Parklawn North: Limited Preliminary Plan Amendment 12011030A and Limited Site Plan Amendment 82011009C

Completed: 7/8/13

Description

Site Plan Amendment C Detail

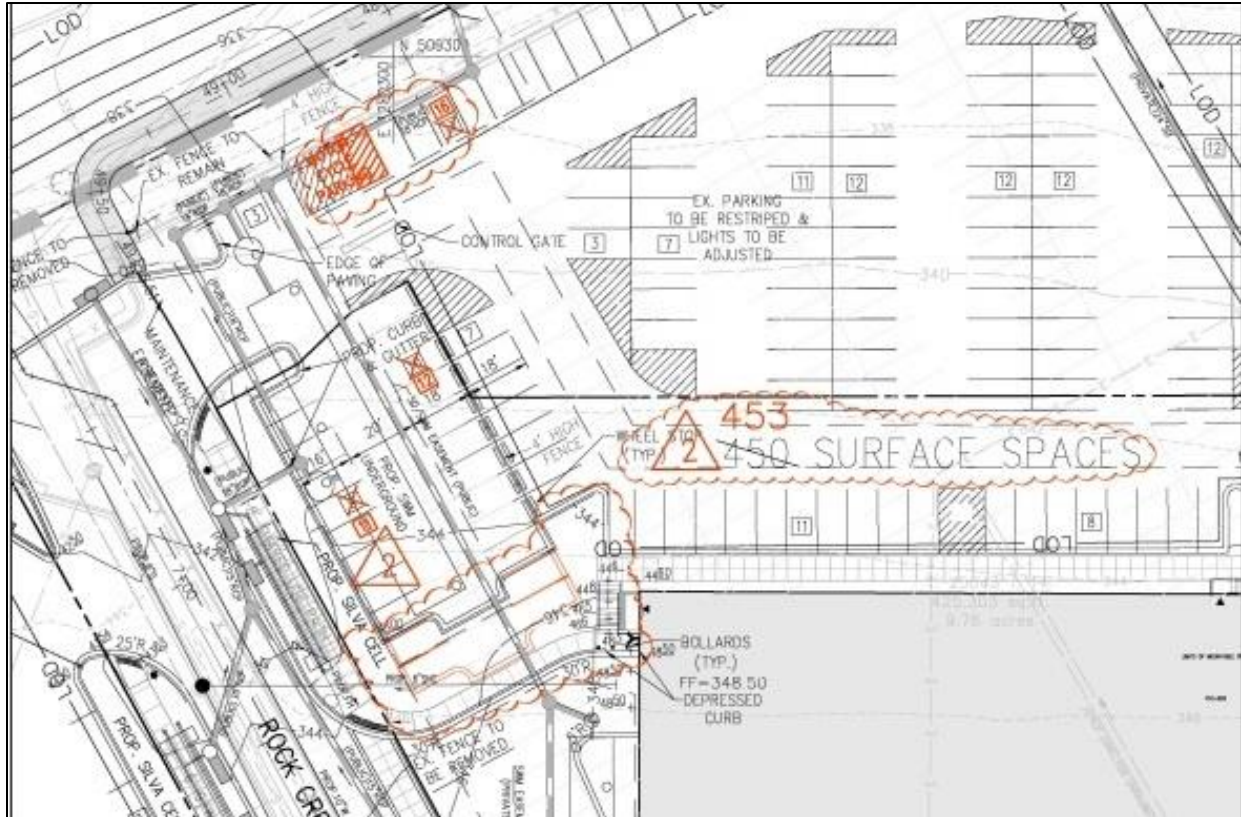
The Applicant is proposing slight alterations to the parking configuration and a slight increase in parking spaces. These modifications will accommodate the reduction in parking caused by a security barrier being proposed in 8201109B. If approved, Site Plan 82011009B would reduce the current surface parking on lot 5 from 452 spaces to 450 spaces and bring the total parking down from the originally approved 1,207 spaces to 1,205 spaces. Site Plan 82011009C, however, would replace those two spaces and add one more for a total of 453 spaces and bring the total parking spaces up to 1,208.

These modifications to the parking will reduce the on-site public use space from 50,155 square feet or 22% of the area to 49,036 square feet or 21.5% of the area. This still exceeds the 20% minimum public use space requirement in the TMX-2 zone.
